From: giles giles
Sent: 28/06/2022 5:36:23 PM
To: Council Northernbeaches Mailbox
Cc: kam kam
Subject: DA comment Submittal for DA2022/0688 33, 35 Fairlight street
Attachments: 33 35 fairlight street development submittal.pdf; submittal for DA2022 0688 33, 35 Fairlight street from Giles Newcombe.docx;

Regarding Development Proposal DA2022/0688 at 33 and 35 Fairlight Street, Fairlight.

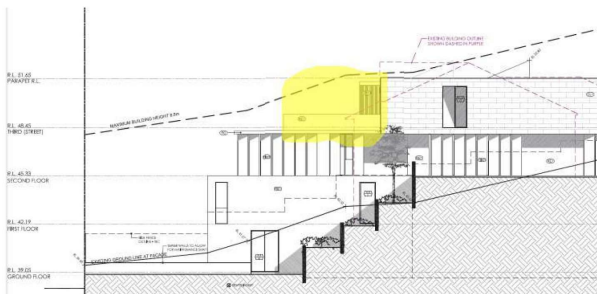
1. As below, Masterplan side elevation details an illustrative tree which obscures a tiled area on Level 2 that is accessed via a sliding door - This fully accessible terraced area would look directly into 31 fairlight street units – resulting in privacy concerns (there may also be similar privacy concerns on the opposite side of the building and lower levels of 37 Fairlight street)

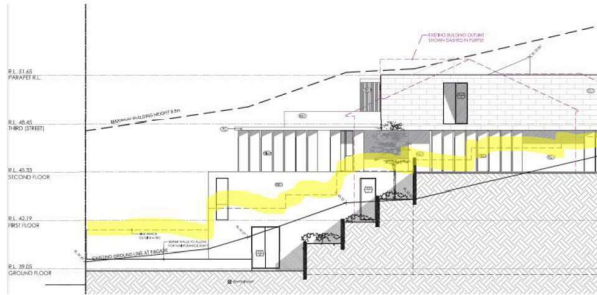
2. Unlike Level 2 – level 3 terrace has not been provided with any side privacy screening resulting in potential sight lines into 31 Fairlight street units

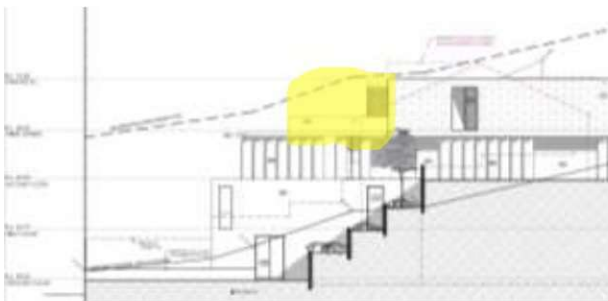
1. As below, Masterplan side elevation details an illustrative tree which obscures a tiled area on Level 2 that is accessed via a sliding door - This fully accessible terraced area would look directly into 31 fairlight street units – resulting in privacy concerns (there may also be similar privacy concerns on the opposite side of the building and lower levels of 37 Fairlight street)

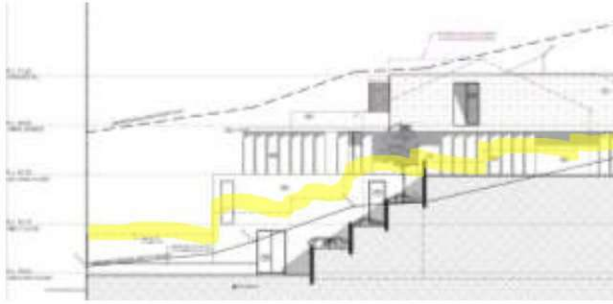
2. Unlike Level 2 – level 3 terrace has not been provided with any side privacy screening resulting in potential sight lines into 31 Fairlight street units
